HISTORIC AND DESIGN REVIEW COMMISSION

September 18, 2019

HDRC CASE NO: 2019-531
ADDRESS: 1518 E GRAYSON ST
LEGAL DESCRIPTION: NCB 1258 BLK LOT A3
ZONING: C-2 IDZ, H
CITY COUNCIL DIST.: 2
DISTRICT: Government Hill Historic District
APPLICANT: Timothy Cone
OWNER: Tim Sanford/1518 GRAYSON LLC
TYPE OF WORK: Exterior modifications, Historic Tax Certification
APPLICATION RECEIVED: September 06, 2019
60-DAY REVIEW: November 04, 2019
CASE MANAGER: Edward Hall

The applicant is requesting a Certificate of Appropriateness for approval to:

**EXTERIOR
ELEVATIONS**

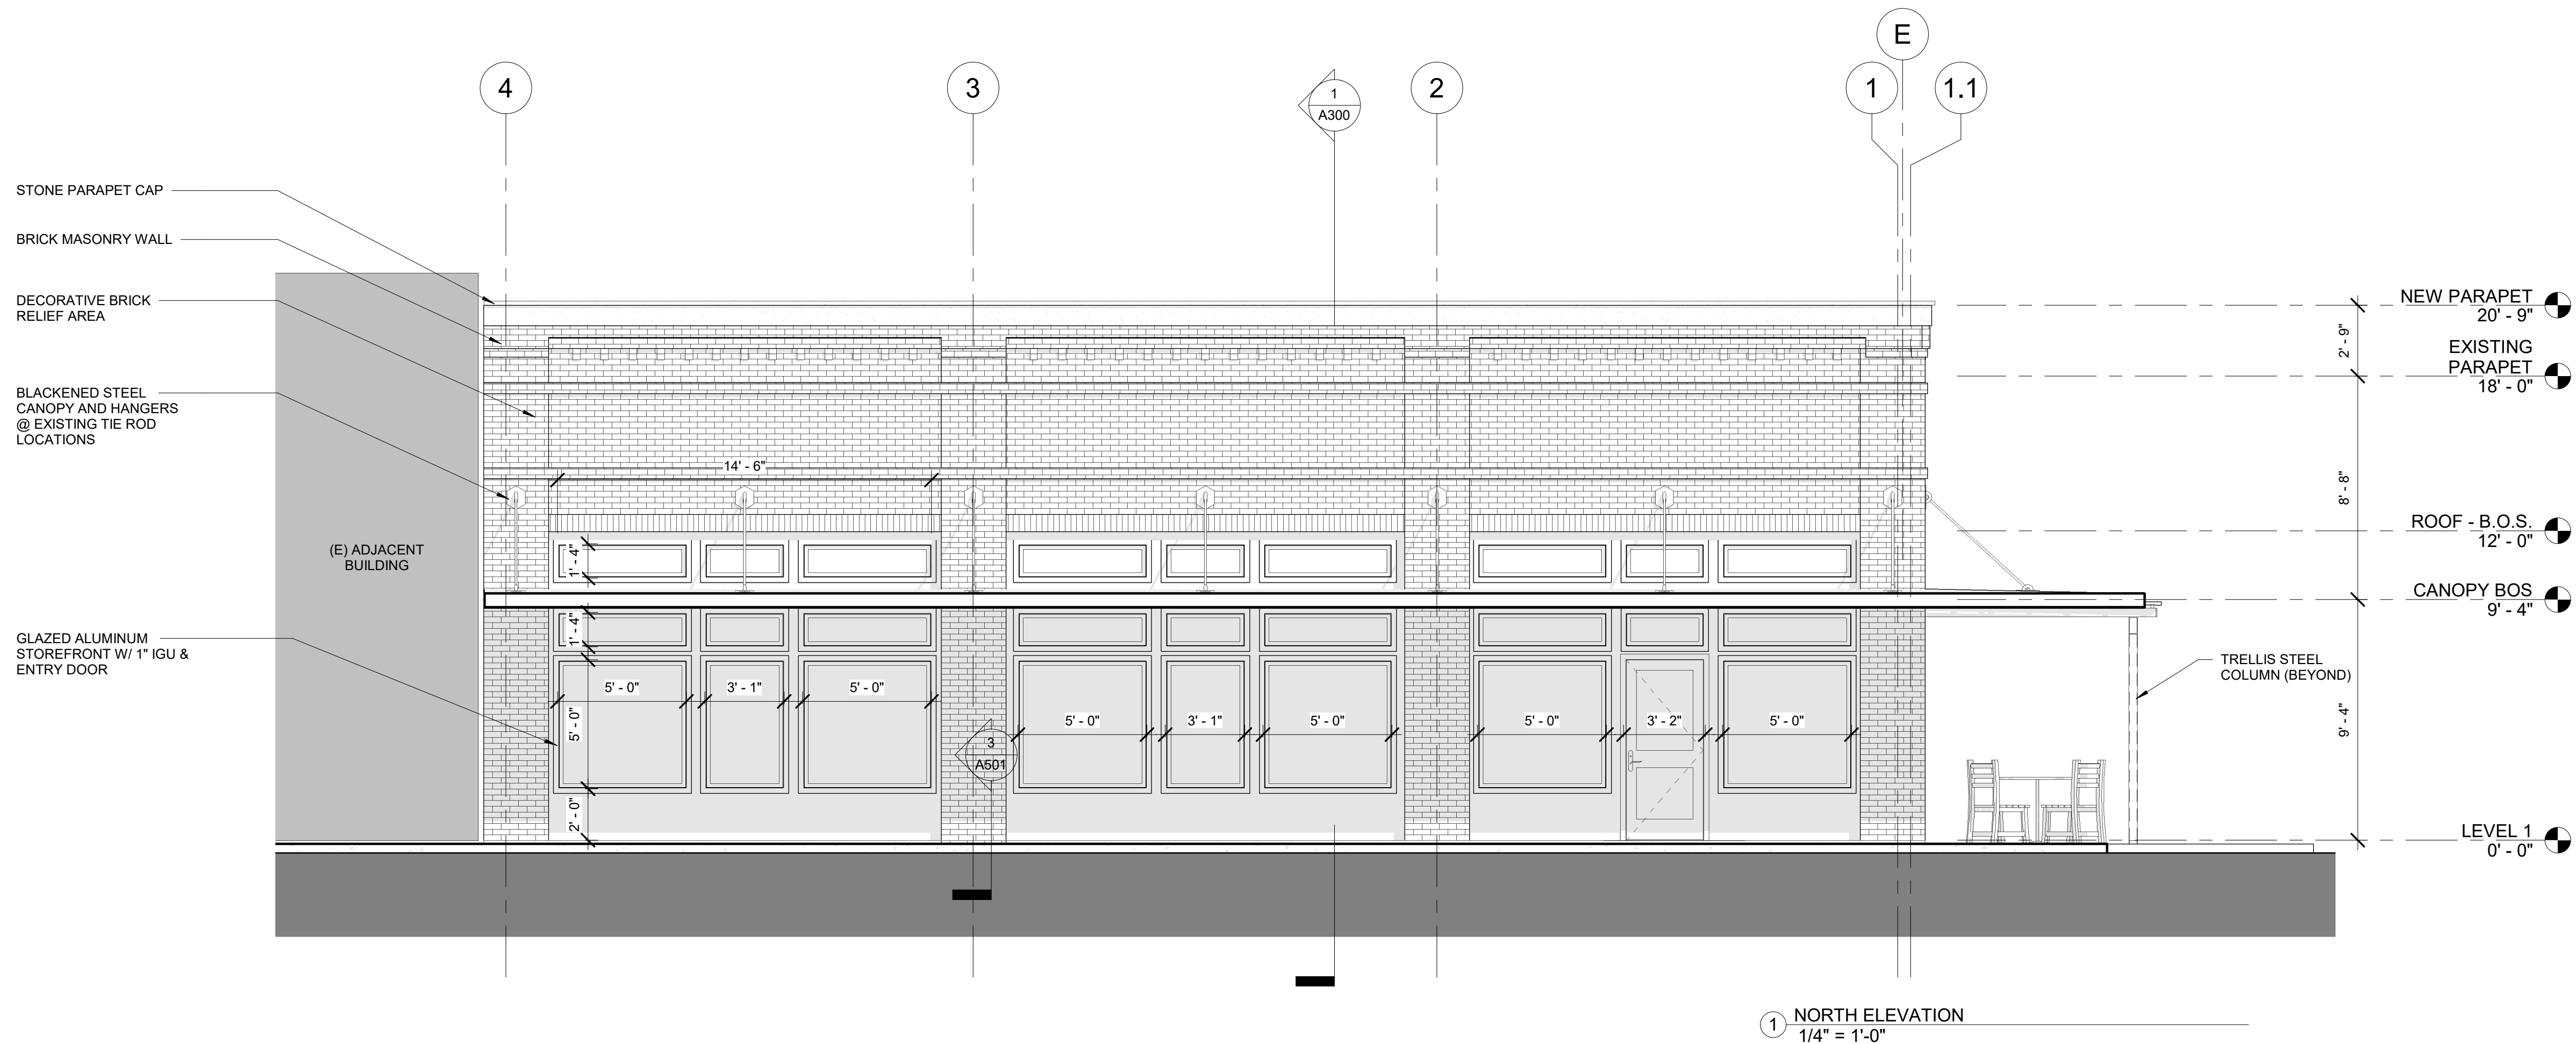
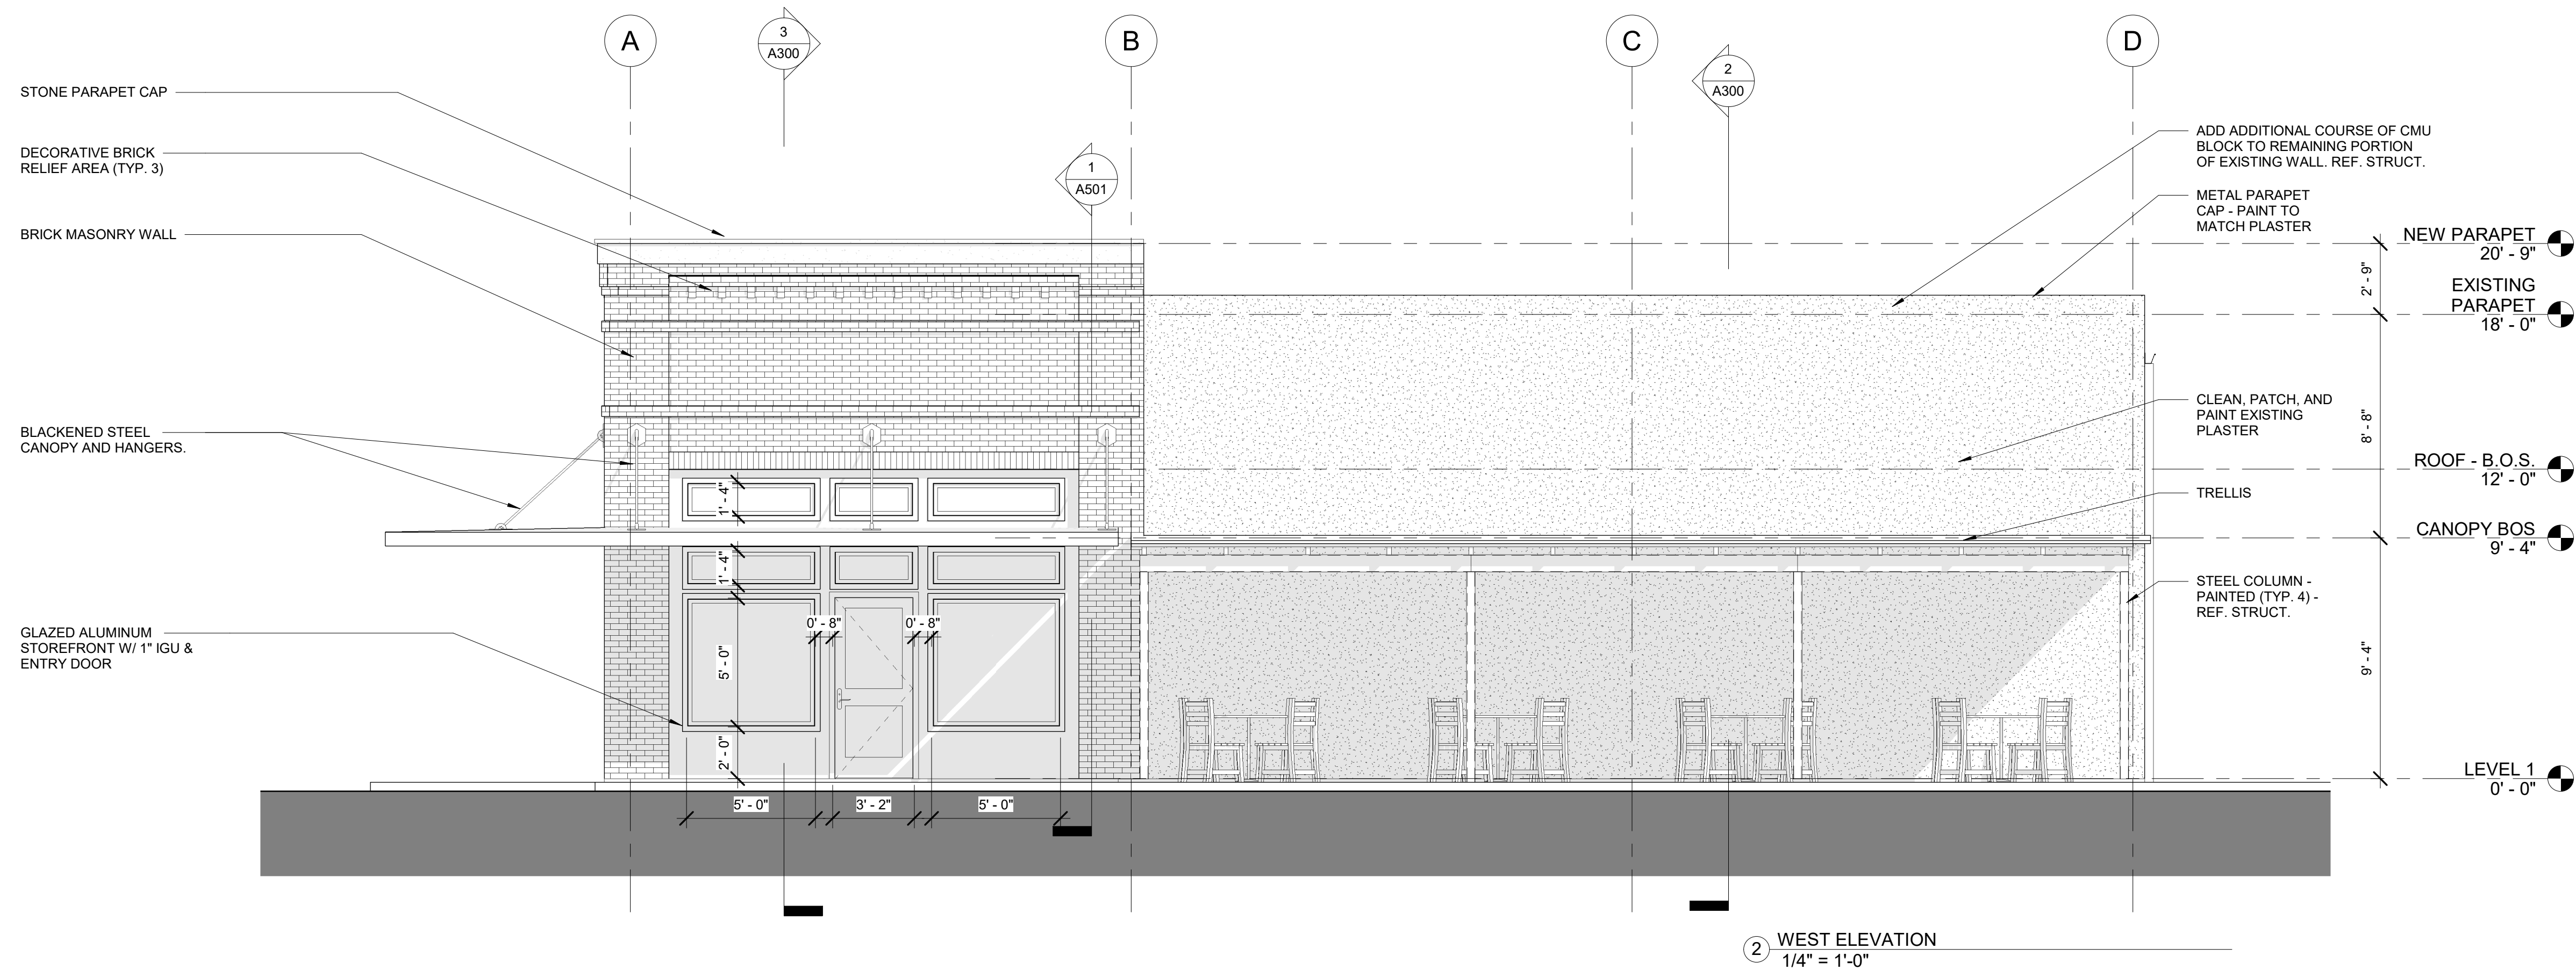
- b. **FAÇADE MODIFICATIONS** – The structure currently features many non-original façade elements, including entrances and storefront elements. The applicant has proposed to install a new brick façade to feature decorative brick courses, a stone parapet cap, and uniform façade depths on both the north and west elevation. A decorative façade previously did not exist on the west elevation. The Guidelines for Exterior Maintenance and Alterations 10.B.ii. notes that non-historic facades should be returned to the original design based on photographic evidence. When evidence of the original is not available, the scale, design, materials, color and texture are to be compatible to those of the historic building. Generally, staff finds that the proposed design is appropriate and consistent with the Guidelines.

- d. **CANOPY** – The applicant has proposed to install a new street canopy on both the north and west facades to replace the existing, non-original canopy. The Guidelines for Exterior Maintenance and Alterations 11. B.ii. notes that new canopies should be added based on accurate evidence of the original, such as photographs. If this evidence does not exist, the design of new canopies should be based on the architectural style of the building. Generally, staff finds the proposed canopy to be appropriate and consistent with the Guidelines.

- e. **COVERED PATIO** – Toward the rear of the west elevation, the applicant has proposed to construct a covered patio for outdoor patio seating. Staff finds this to be appropriate.

- i. That the proposed storefront system feature dark frames and mullions, and that only one vertical storefront panel should be installed beneath the canopy, rather than one large and one small panel beneath the canopy as proposed.
